3. Description of Amendments

3.2 Overview of Proposed Amendments

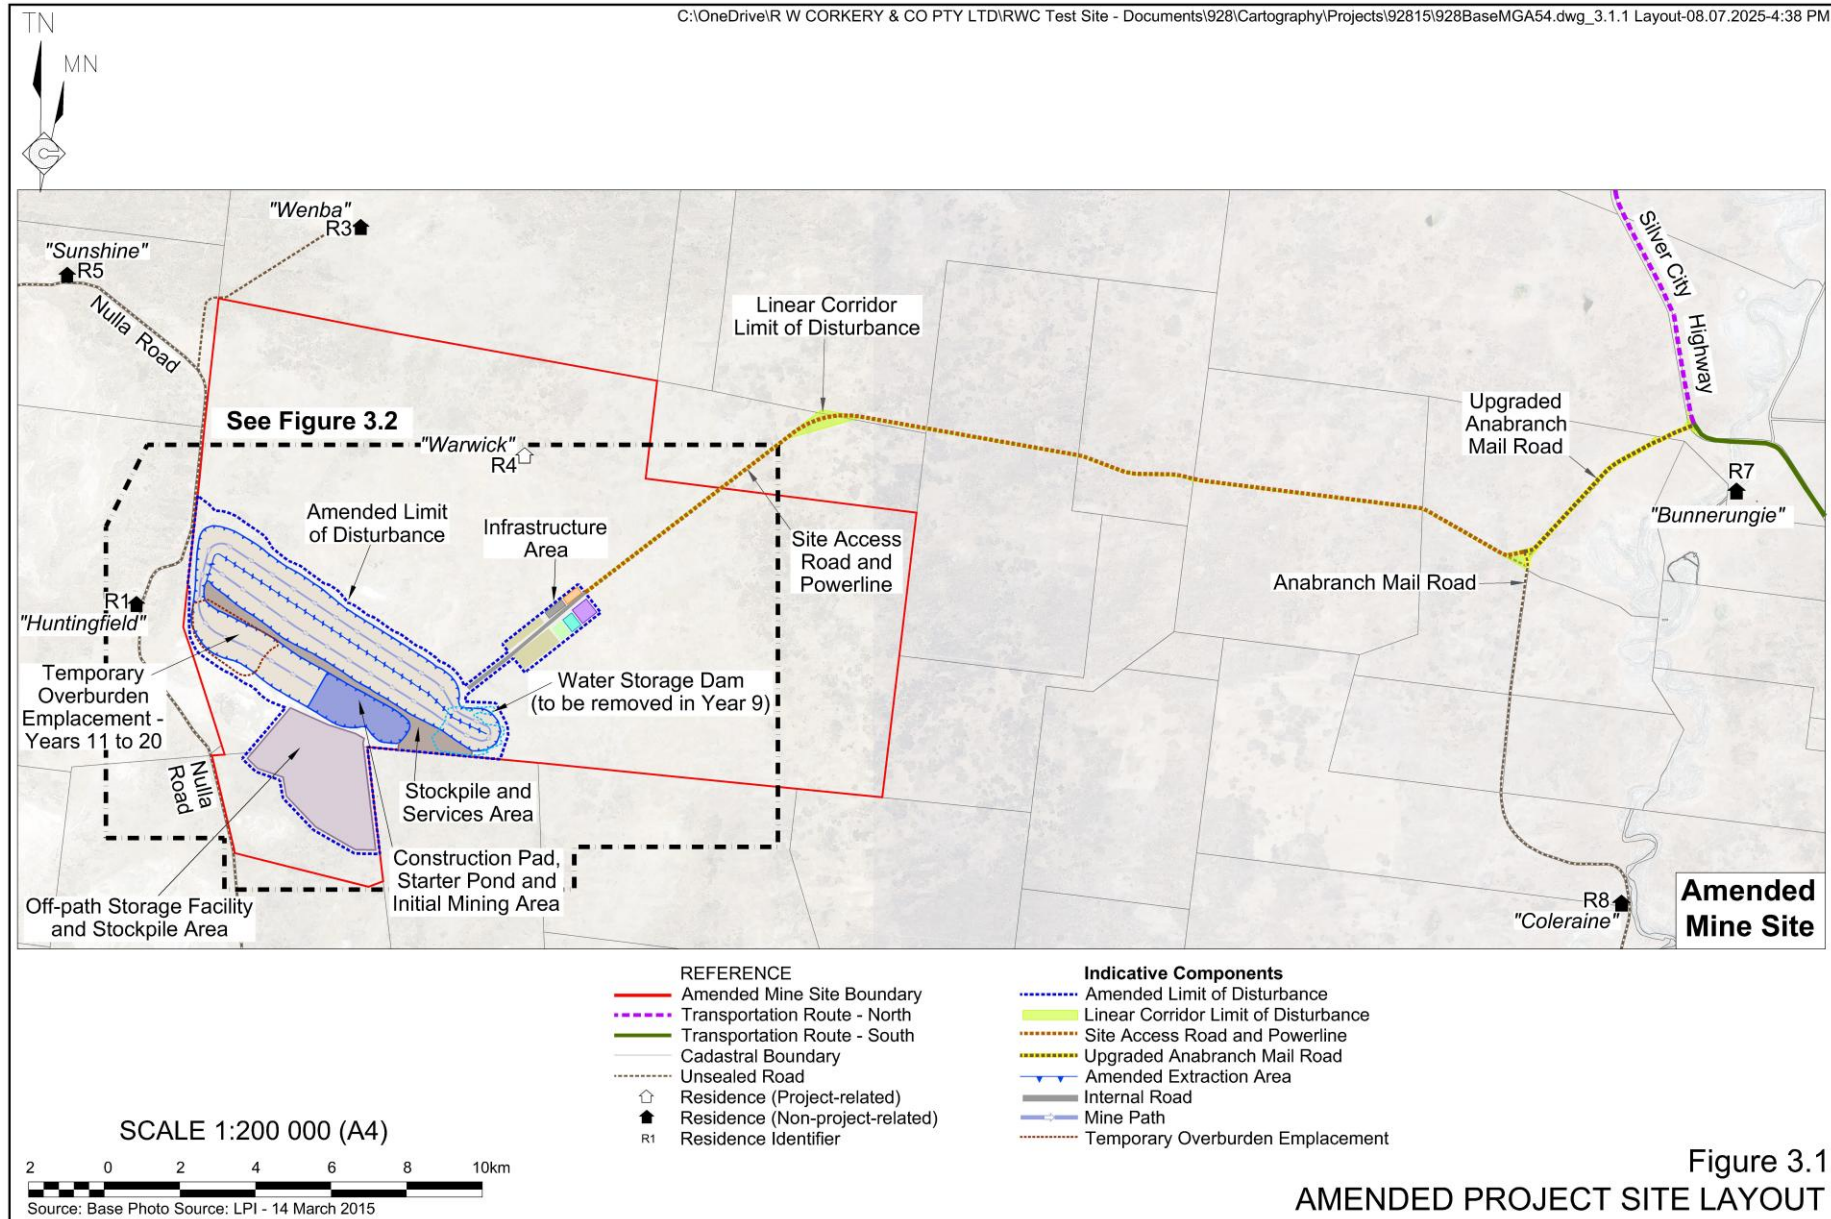
Table 3.1 and Figures 3.1 and 3.2 present an overview of the proposed amendments.

Figure 3.2
AMENDED MINE SITE LAYOUT

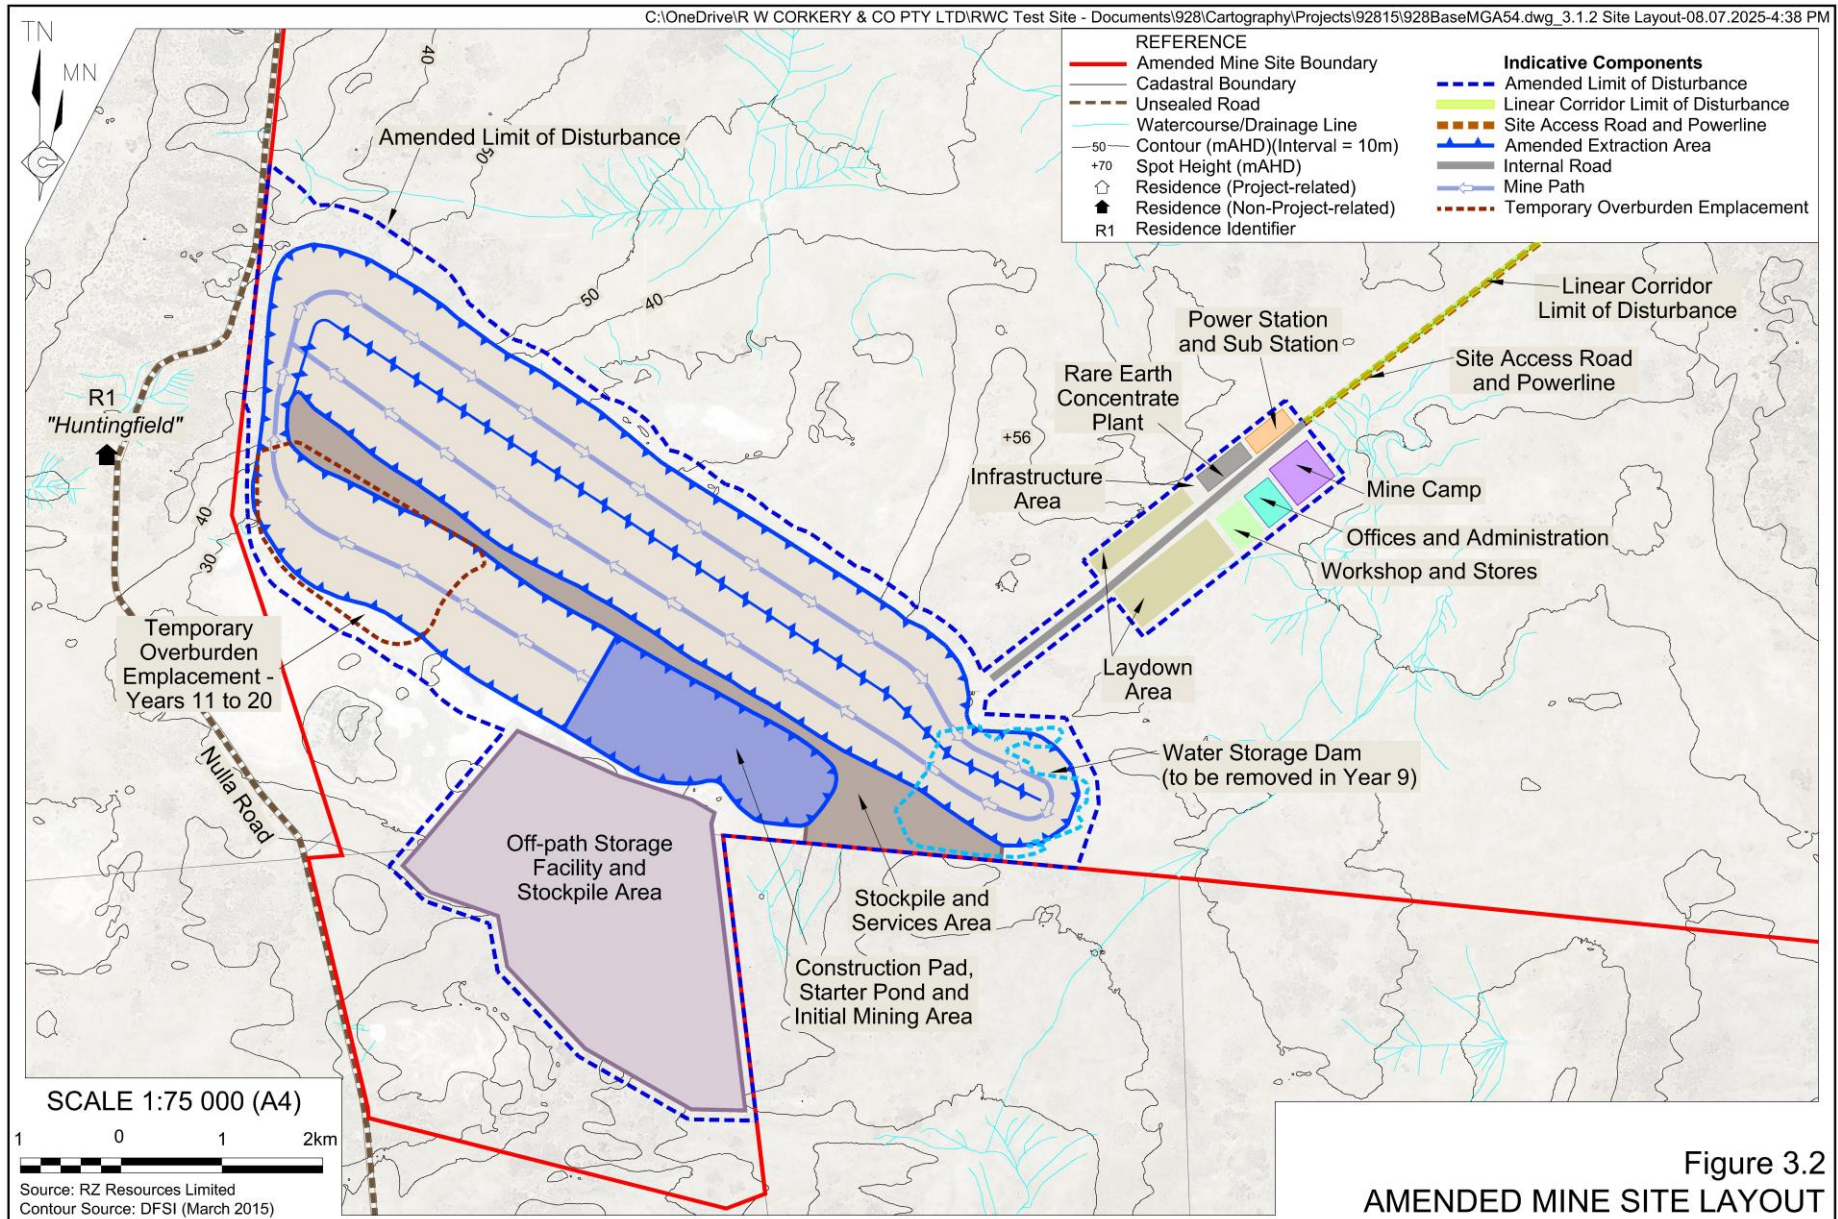
The Applicant proposes to amend the Mine Site and Limit of Disturbance to exclude the following properties.

As a result, the Applicant proposes to amend the layout of the Infrastructure Area as presented on **Figure 3.2**. The limit of disturbance for the Infrastructure Area and the activities undertaken within each of the component areas would remain as described in the EIS.

In response to these changes, the Applicant re-optimised the proposed mining operations using the Datamine Studio NPVS utilising the Lerchs Grossman algorithm. The re-optimisation resulted in an amended Extraction Area and mine schedule that did not require disturbance of land within the Huntingfield and Sunshine Stations (**Figure 3.2**).

Given the complexity of the proposed initial establishment operations, the Applicant continues to optimise this aspect of the Project. As a result, the exact location of the construction pad and starter pond has yet to be determined. **Figure 3.2** therefore presents an amended construction pad, starter pond and initial mining area within which the initial Extraction Area establishment and Yeas 1 and 2 mining operations would be undertaken.

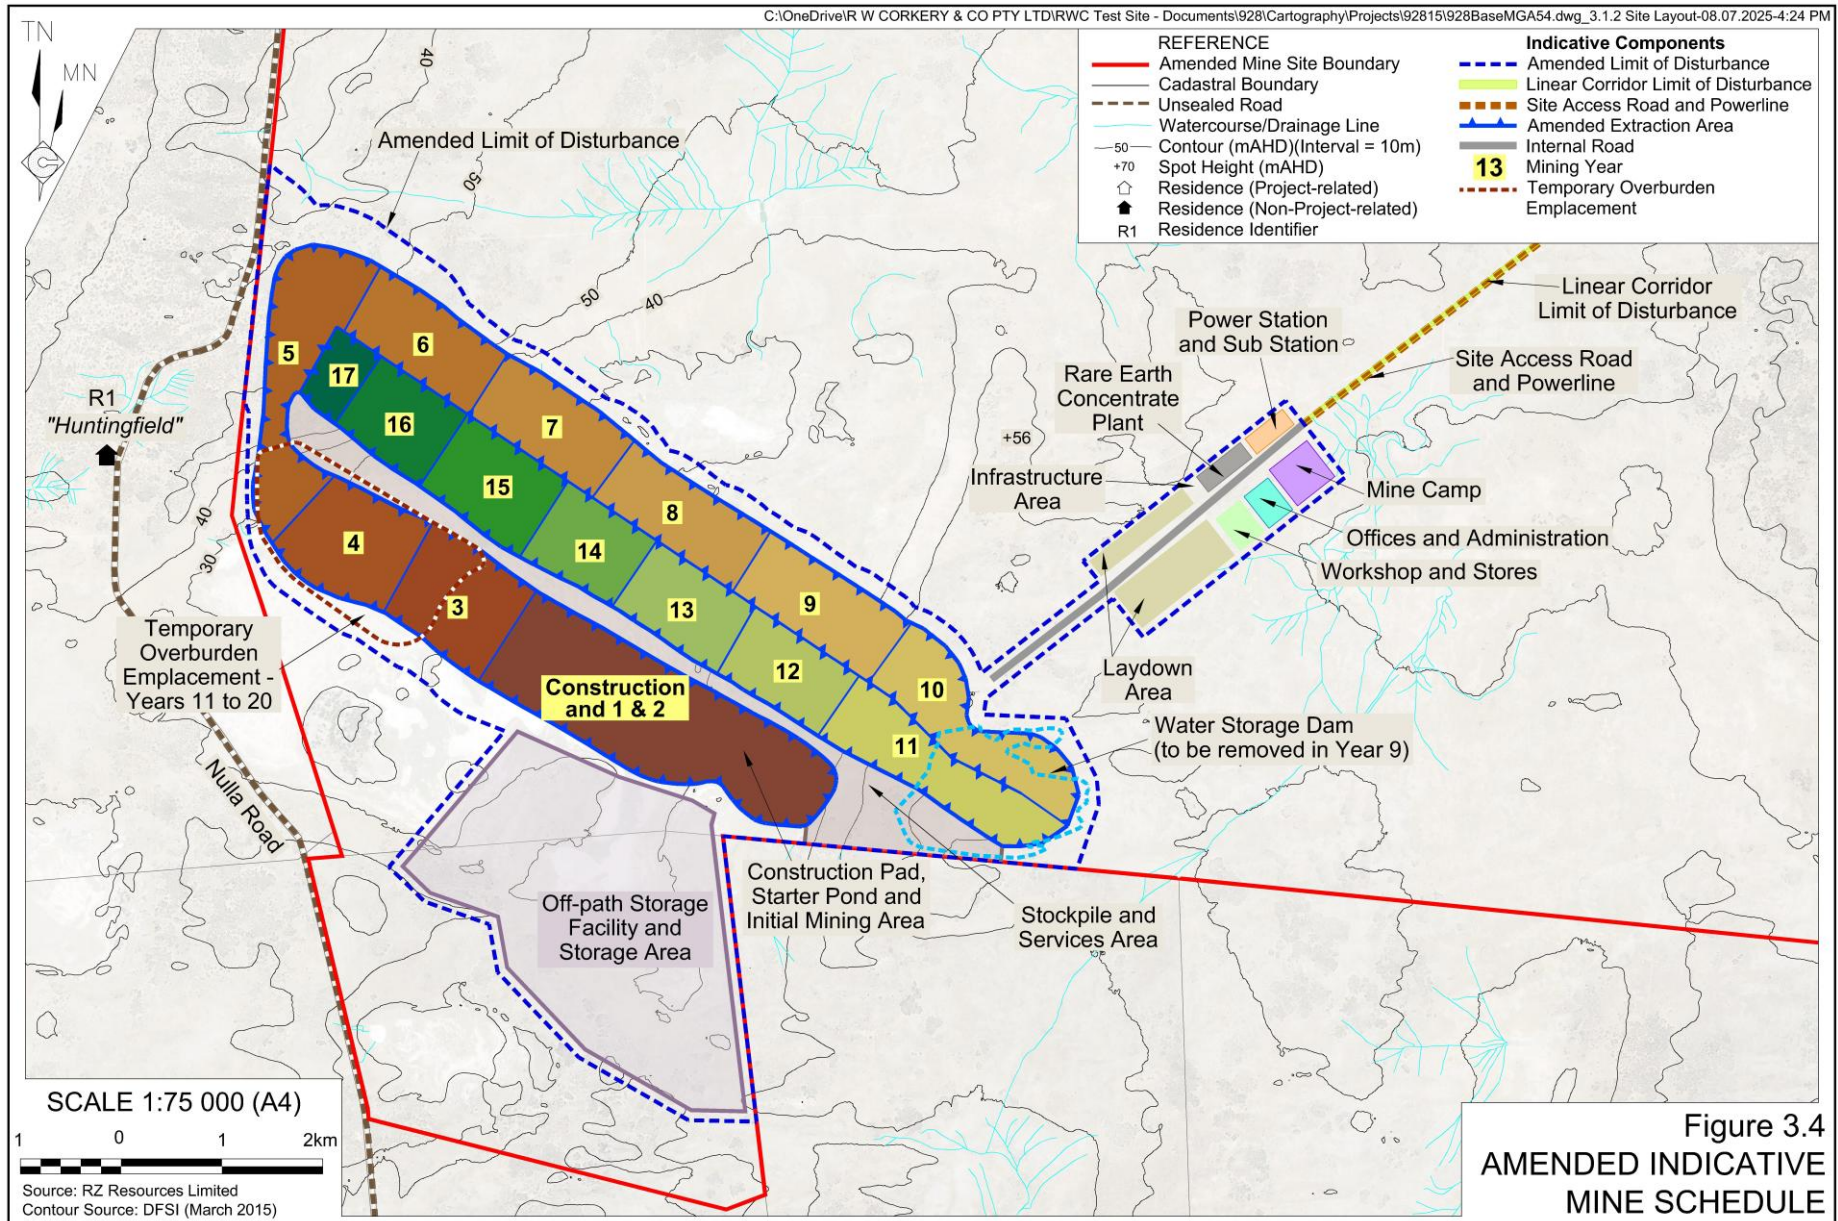
Figure 3.4 presents the mining schedule for the amended Project. In summary, following an initial 3 year construction period, mining is expected to continue for a further 18 years. Table 3.4 presents the amended material movement schedule.
